Response to Comments for the Rocky Ridge Apartments Initial Study/Mitigated Negative Declaration (IS/MND)

The Initial Study/Mitigated Negative Declaration (IS/MND) for the proposed Rocky Ridge Apartments project (PL23-0351) was issued on April 4, 2025 and circulated for public review and comment over a 20 day period that ended on April 24, 2025. The California Environmental Quality Act (CEQA) requires a review period of no less than 20-days for MNDs (Refer to CEQA Guidelines Section 15073(a)). During the public review period, the City received two (2) comments on the IS/MND. One comment was a letter was from the Maidu Neighborhood Association Committee and one comment was an email from an individual. The complete text of the written comments, and the City's responses to those comments is presented in this section. A copy of each comment, marked in the margin with the response numbering, is followed by its corresponding response(s). Good faith, reasoned, factual responses have been provided to all comments received that raise environmental issues. Detailed responses have been provided where a comment raises a specific issue, and a general response has been provided where the commen

Attachment 1

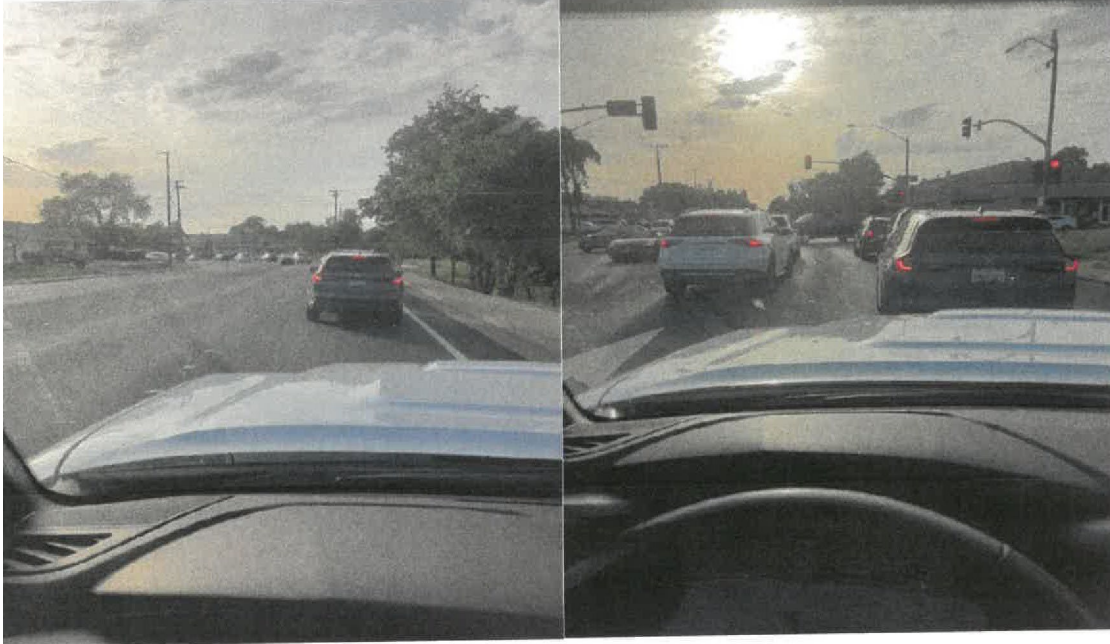
- a. "Squeeze" past other vehicles (stopped and waiting at the traffic light) or
 - b. Wait for the signal light to change if "squeezing" past other vehicles is not possible. The later can cause more vehicles to be stopped at the intersection increasing traffic and forcing drivers to wait for two or three traffic signal cycles to

clear the intersection (refer to Attachment 1).

3. The MNA committee is asking the city to use discretion by adding a dedicated right turn lane on westbound South Cirby Way to proceed northbound on Rocky Ridge Drive. The absence of a right turn lane is *already a traffic issue* and is expected to become worse.

Response to Comment #15: The comment requests a right turn lane be installed on westbound South Cirby Way. The City's Capital Improvement Program does not include a designated right turn lane from westbound South Cirby Way to northbound Rocky Ridge Drive. Therefore, the intersection is already constructed to its ultimate configuration and the proposed development is not being conditioned to construct additional intersection improvements. Per the previous responses (Responses #3 and #4), the traffic that will be generated from this projected has already been anticipated in the City's Traffic Demand Model that is used to determine intersection configurations, and the nine additional peak hour trips added by the project to the existing condition will not have significant impacts on intersection operations.
